CITY OF ALBUQUERQUE

**RE: Monterey Walk Townhomes
12001 Sierra Grande Ave. NE
Grading and Drainage Plan
Engineer's Stamp Date: 07/20/20
Hydrology File: J22D012E**

DRAINAGE AND TRANSPORTATION INFORMATION SHEET (REV 11/2018)

GRADING AND DRAINAGE PLAN
MONTEREY WALK TOWNHOMES
12001 SIERRA GRANDE N.E.

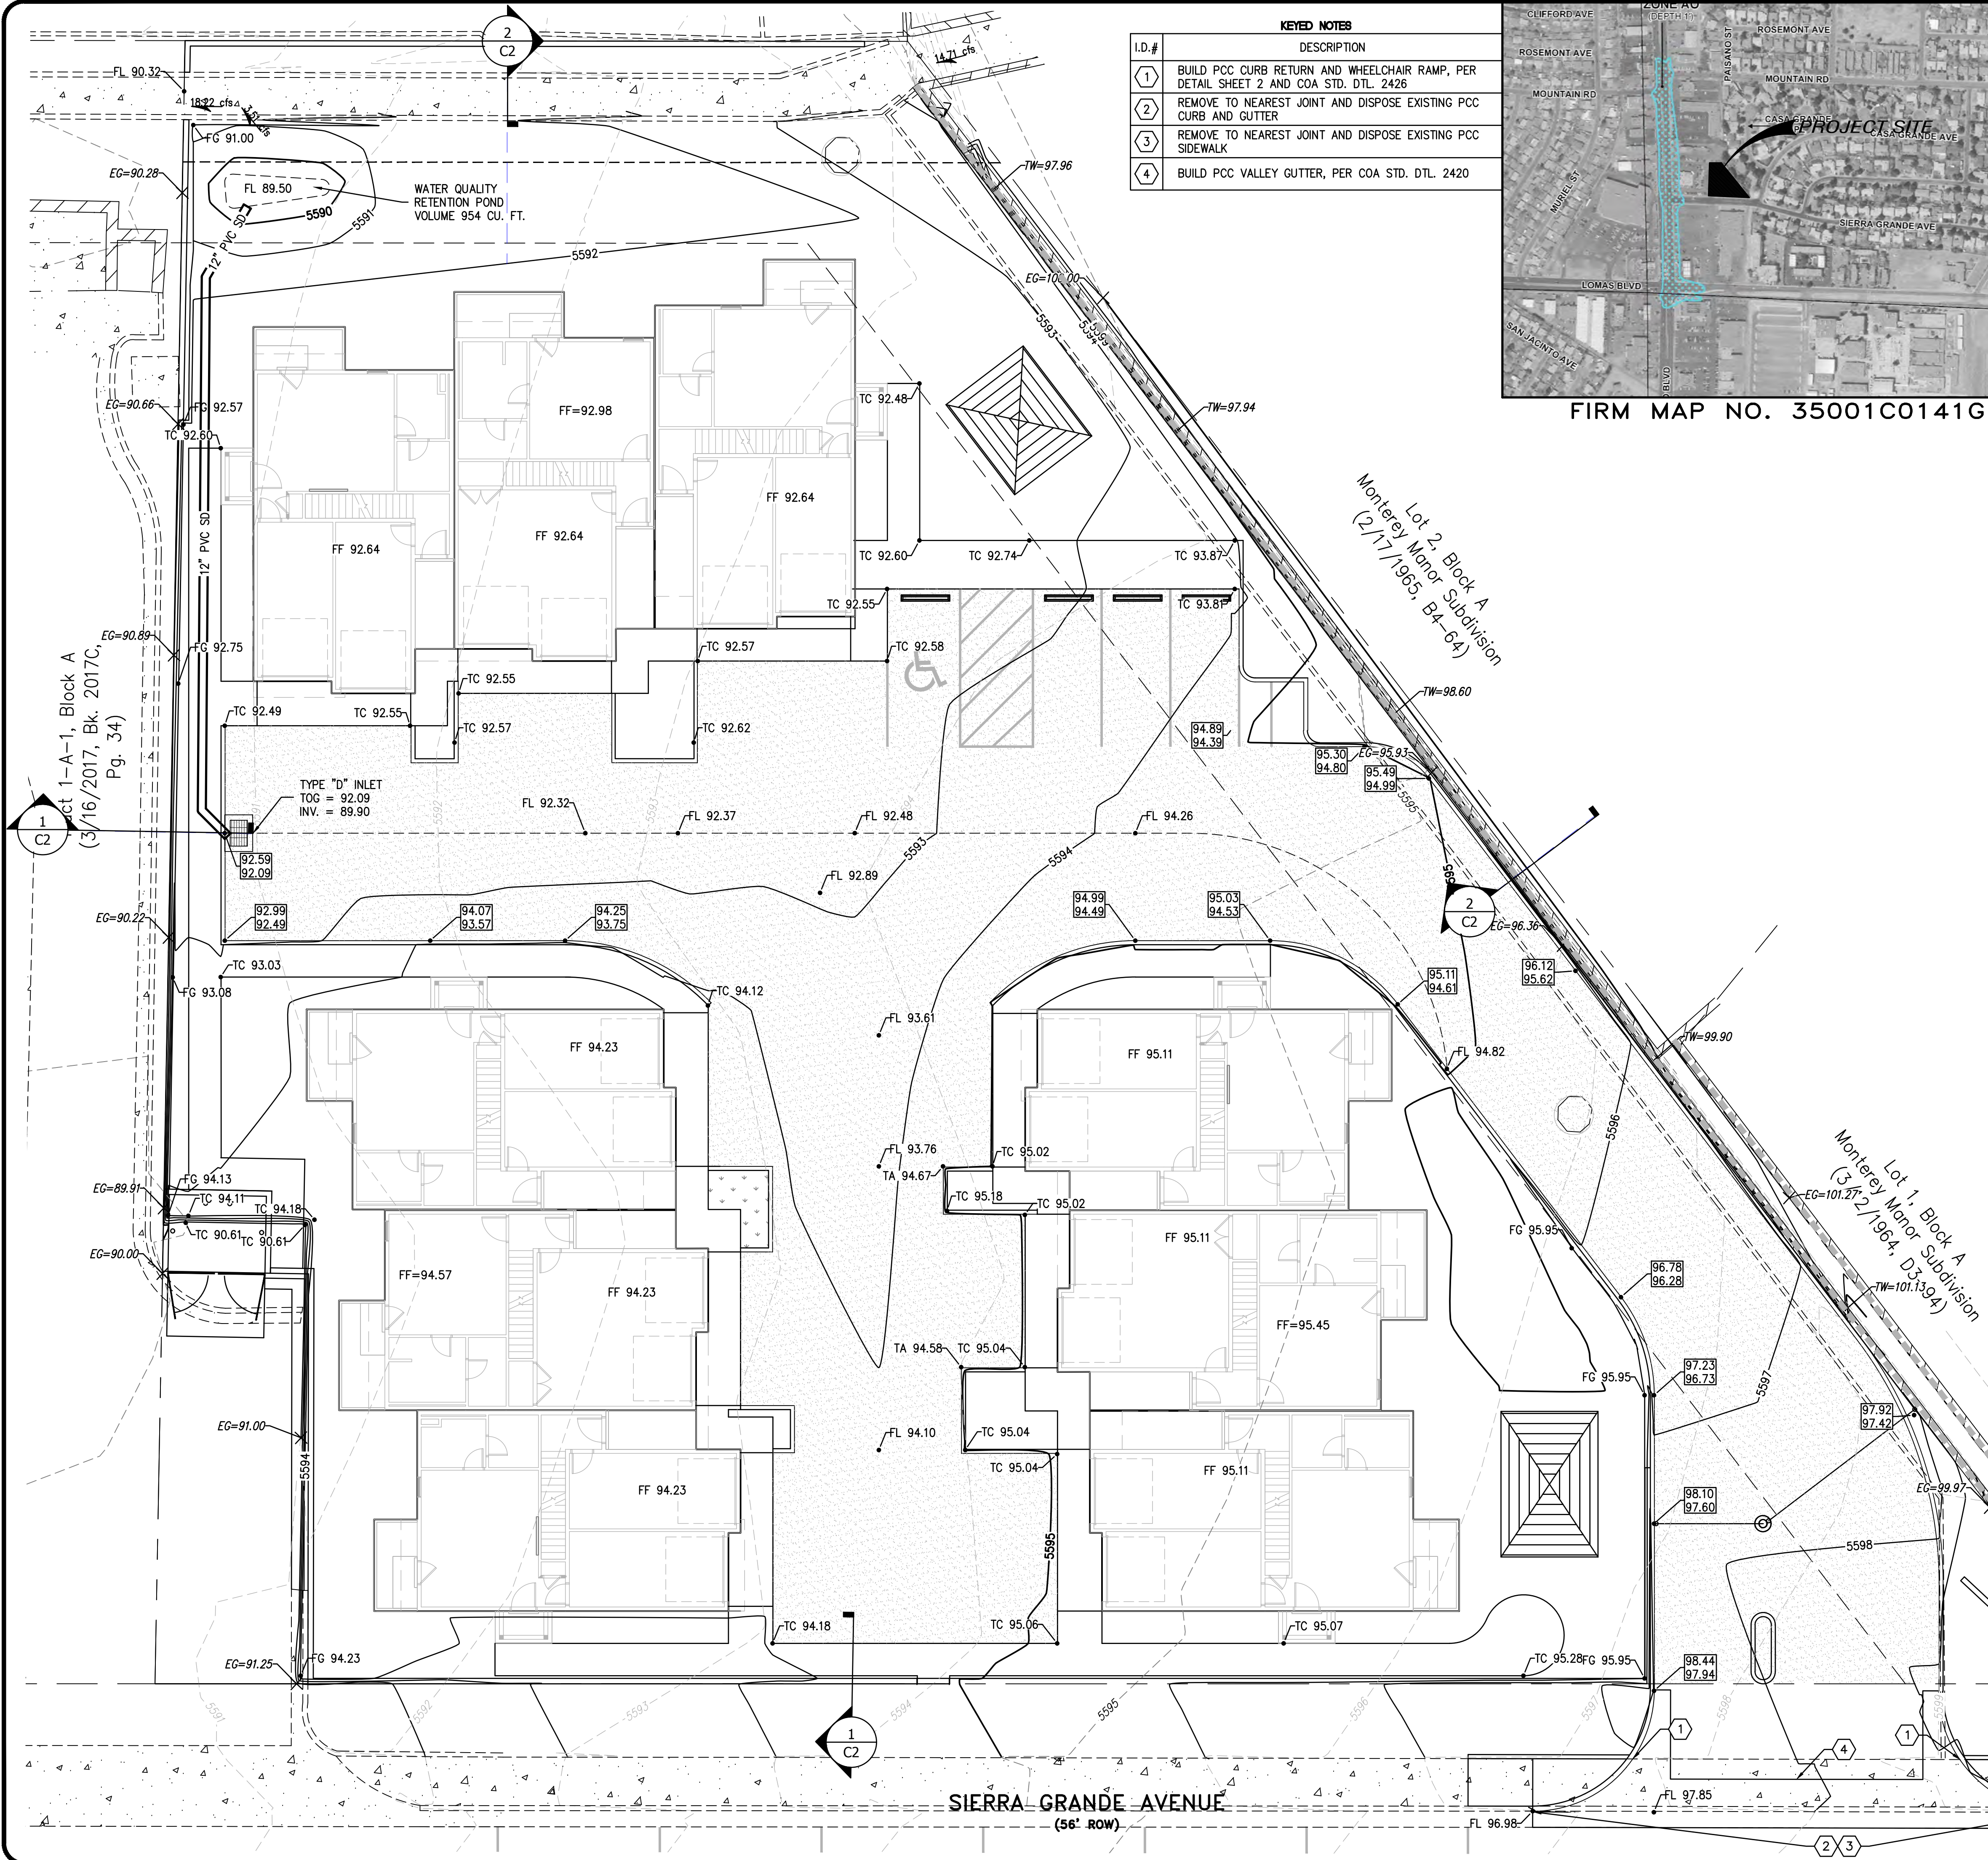
Based upon the information provided in your submittal received 07/22/2020, the Grading & Drainage Plan is approved for Building Permit.

Please attach a copy of this approved plan in the construction sets for Building Permit processing along with a copy of this letter. Prior to approval in support of Permanent Release of Occupancy by Hydrology, Engineer Certification per the DPM checklist will be required.

As a reminder, if the project total area of disturbance (including the staging area and any work within the adjacent Right-of-Way) is 1 acre or more, then an Erosion and Sediment Control (ESC) Plan and Owner's certified Notice of Intent (NOI) is required to be submitted to the Stormwater Quality Engineer (Doug Hughes, PE, jhughes@cabq.gov, 924-3420) 14 days prior to any earth disturbance.

Also as a reminder, please provide a Drainage Covenant for the proposed Stormwater Quality Ponds per Chapter 17 of the DPM prior to Permanent Release of Occupancy. Please submit this on the 4th floor of Plaza de Sol. A \$25 fee will be required.
